UNITED STATES PATENT AND TRADEMARK OFFICE

| APPLICATION NO. | FILING DATE | FIRST NAMED INVENTOR | ATTORNEY DOCKET NO. | CONFIRMATION NO. |
|-----------------|-------------|----------------------|---------------------|------------------|
| 10/532,430 | 04/25/2005 | Kenji Yamane | OGW-0365 | 1792 |

| Office Action Summary | Application No. | Applicant(s) | |

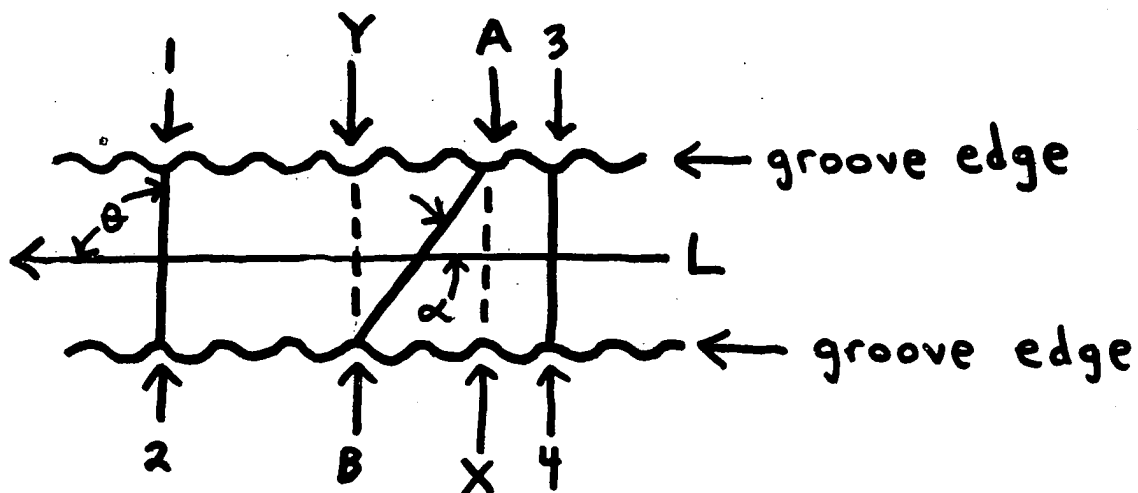
Heinen teaches providing the peaks and valleys on a first side such that they 180 degrees out of phase from the peaks and valleys on the second side surface. Attention is directed to the following figure:

The undulating lines in the above figure represent the edges of a groove at the tread surface. The peaks and valleys at one groove edge are 180 degrees out of phase from the peaks and valleys at the other groove edge. For example, peak 1 is directly opposite peak 2. Another example, peak 3 is directly across from peak 4. A continuous peak can extend from peak 1 to peak 2 along a line inclined at angle θ with respect to the line L (the longitudinal direction of the groove) wherein angle θ is 90 degrees. However, a continuous peak can extend from peak A to peak B along a line inclined at angle α with respect to line L (the longitudinal direction of the groove). This is true even though peak A is directly across from peak X and peak B is directly across from peak Y. The path of a continuous peak from one groove edge to the other groove edge is independent of the phase of the peaks at the tread surface. More importantly, Heinen fails to require peaks and valleys on one side surface to be 180 degrees out of phase from the peaks on the other side surface. In Heinen, the longitudinal direction of groove corresponds to the imaginary line or arc located on the median plane within the depth of the groove wherein the median plane bisects the channel formed by the respective surfaces of the groove. See col. 5 lines 59-67. Heinen teaches that the peaks and valleys follow imaginary lines that are skewed with respect to the median plane line or arc at 45 to 90 degrees. See col. 6 lines 1-4. Heinen teaches that the lines are skewed at 90 degrees in the preferred embodiment, which is illustrated in figure 7. See col. 4 lines 28-29, col. 6 lines 4-7. With respect to this skewing at an angle of 45-90 degrees, Heinen explains:
